OVERVIEW HILLS

AN ADDITION TO SEDGWICK COUNTY, KANSAS

RE: SUB 2001-51 -- Final Plat of Overview Hills Addition

At the regular meeting of the Subdivision Committee of the Metropolitan Area Planning Commission on Thursday, June 14, 2001, the above captioned plat was considered. The action of the Committee was to approve the final plat, subject to the following:

*Sheet from final 9-4-01
tracing
p 2 of 2*

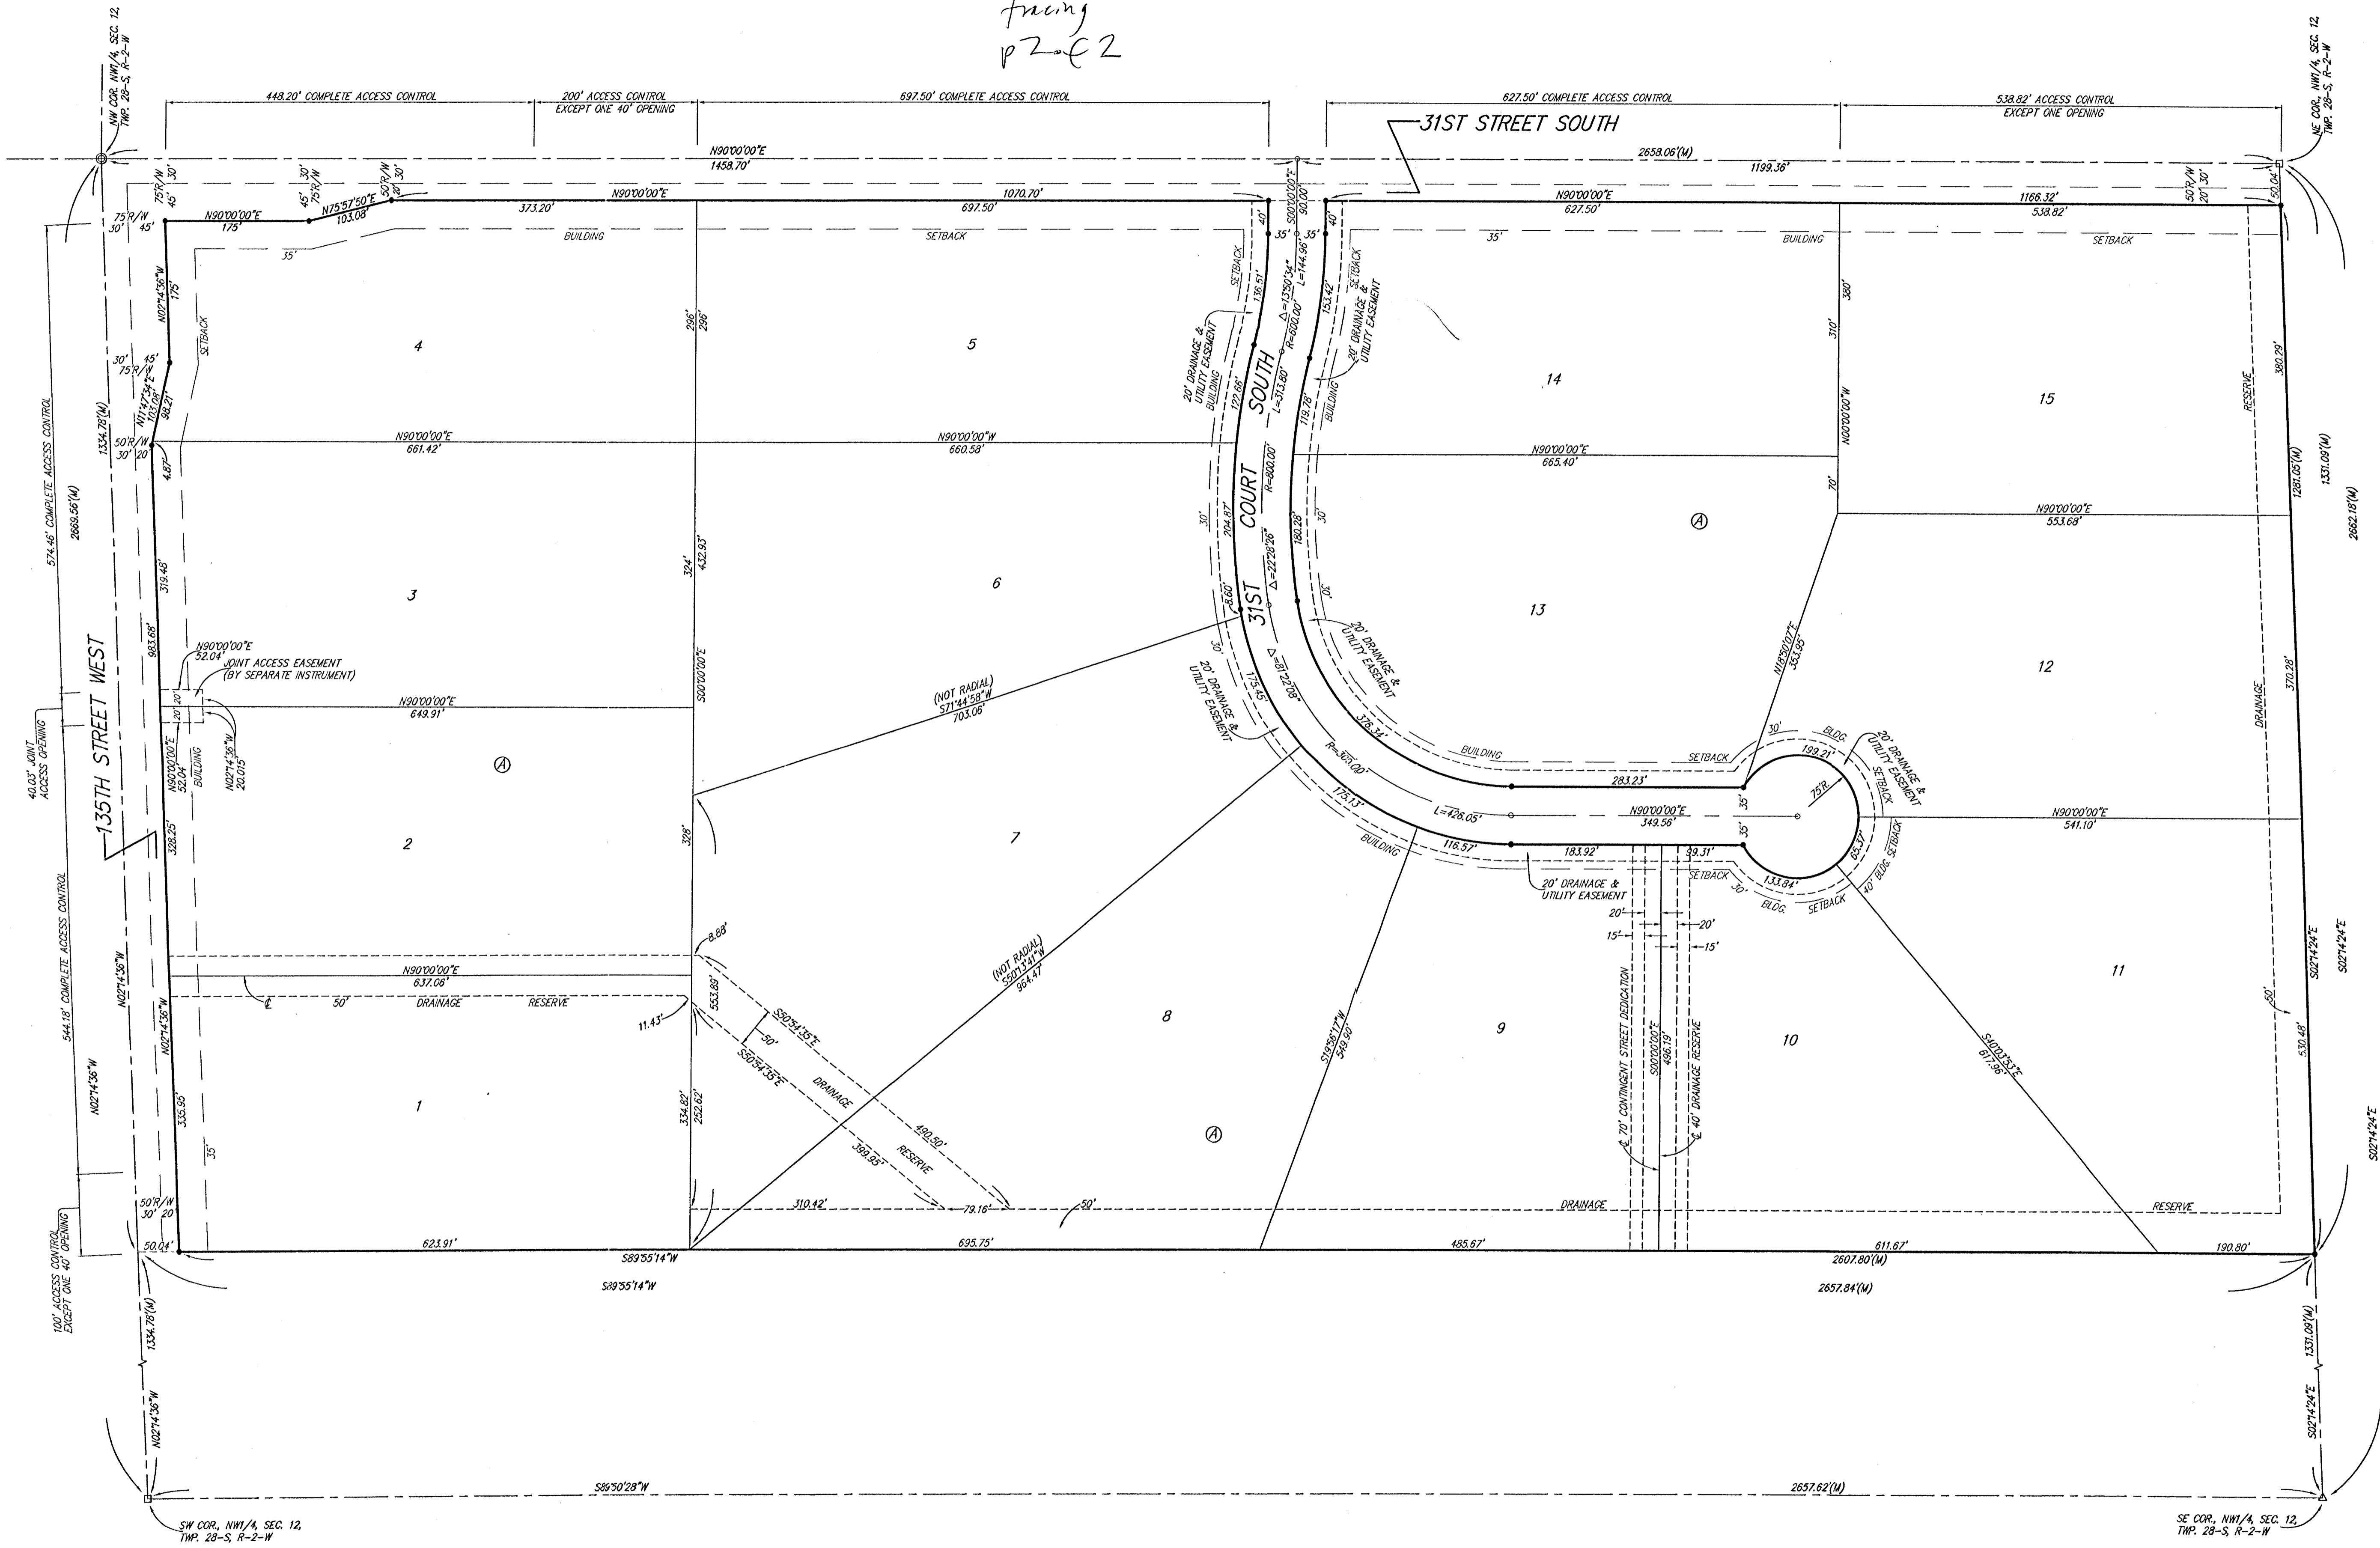
- F. County Engineering needs to comment on the access controls. The plat proposes two access openings along 31st St. South, and two openings along 135th St. West, including one joint opening. *The access controls are approved. The 40-ft joint access opening shall be specified.*

- J. Approval of this plat will require a waiver of the lot depth to width ratio of the Subdivision Regulations for Lots 6, 7, 8, and 11. The Subdivision Regulations state that the maximum depth of all residential lots shall not exceed 2.5 times the width. *The Subdivision Committee has approved the modification.*

- M. Lot 11 may not meet the 100-ft lot width requirement which is measured at the building setback line. This dimension should be denoted on the final plat. An increase in the distance of the building setback from the road would meet the standard. *The building setback has been increased to 40 feet.*

- N. In the surveyor's certificate and the plat's text, the word "estates" needs to be removed.
- O. The centerline of 31st Street Court needs to be located along 31st St. South.

- P. The location and elevation of permanent on-site Bench Mark needs to be added.
- Q. The plat's text should be corrected to specify "an Addition to ...".

- R. The Planning Commission Certificate needs to have "Kansas" removed from over the word "Sedgwick" and added after the word "Wichita" at the end.
- S. The plat's text shall include language that a drainage plan has been developed for the plat and that all drainage easements, rights-of-way, or reserves shall remain at established grades or as modified with the approval of the applicable City or County Engineer, and unobstructed to allow for the conveyance of stormwater.
